## Review Comments #2

**Project:** Brighton Recovery Campus-Building F  
**Project No:** 20160686

**From:** Jason Worthen  
**Date:** March 20, 2017

### BUILDING F RESPONSES

EP601

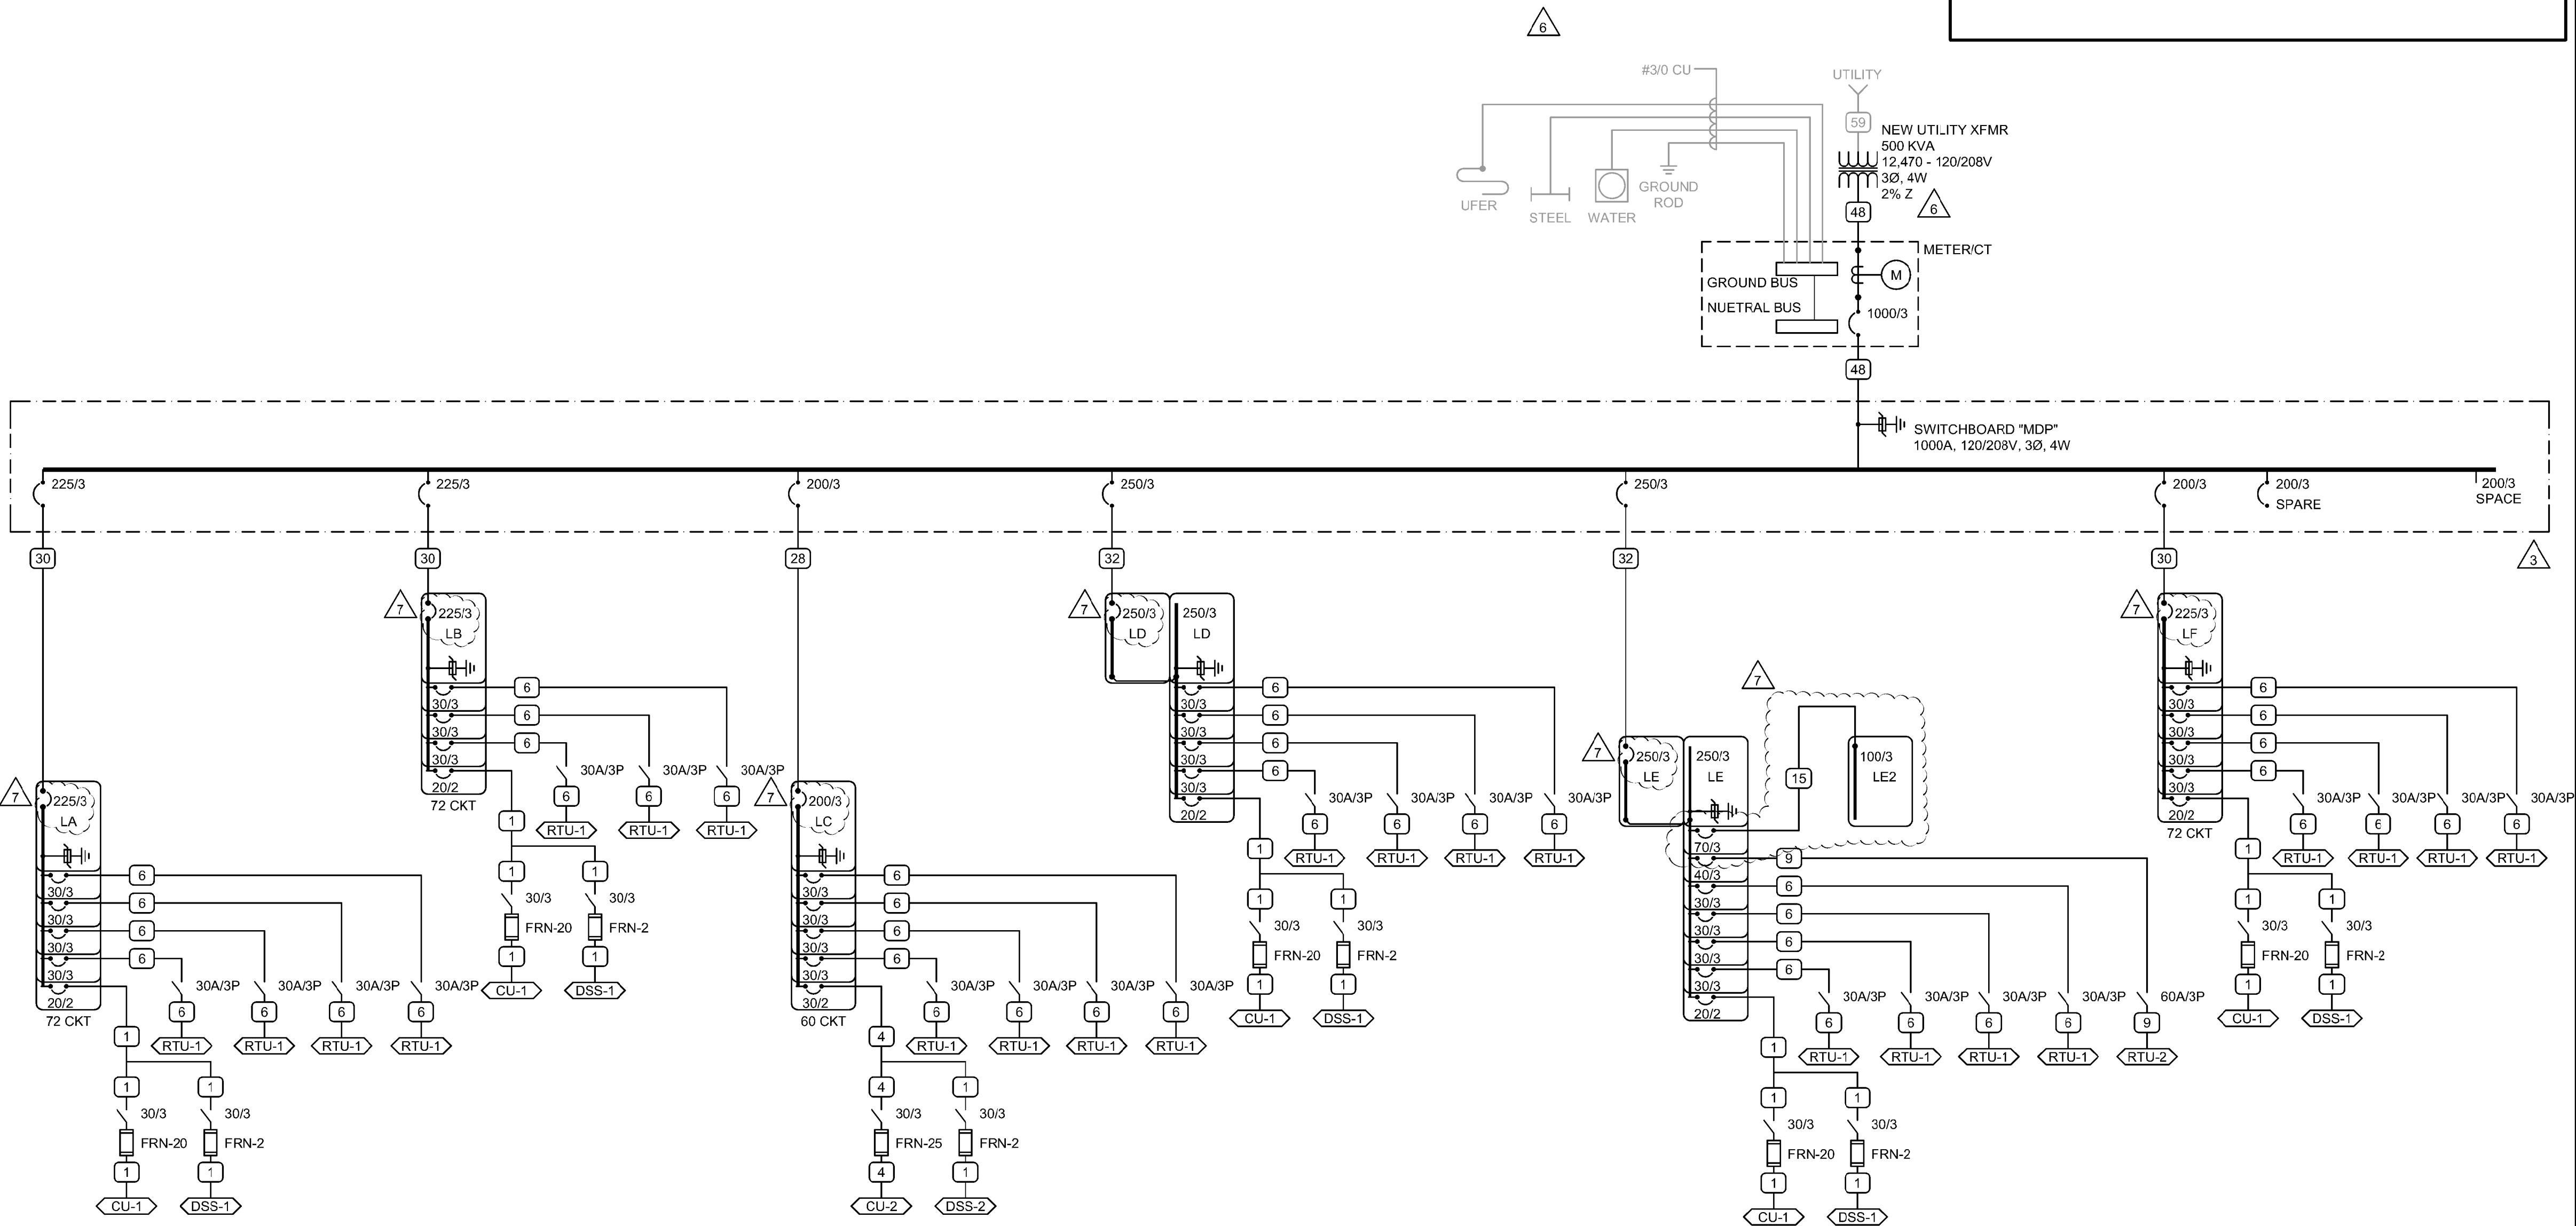
PC2: Sheet EP601: Per NEC 225.32 the main panel in each building is required to have a disconnecting means located at the point of entrance of the building. It appears that each of the building panels are provided with main lugs only. Please provide a disconnect for each panel. This comment also applies to sheets EP602 and EP603.

1. Changed all branch circuit panels from main lugs only to main circuit breaker panels.
2. Added panel LE2.

Response: All branch panels will be changed to have main circuit breakers.
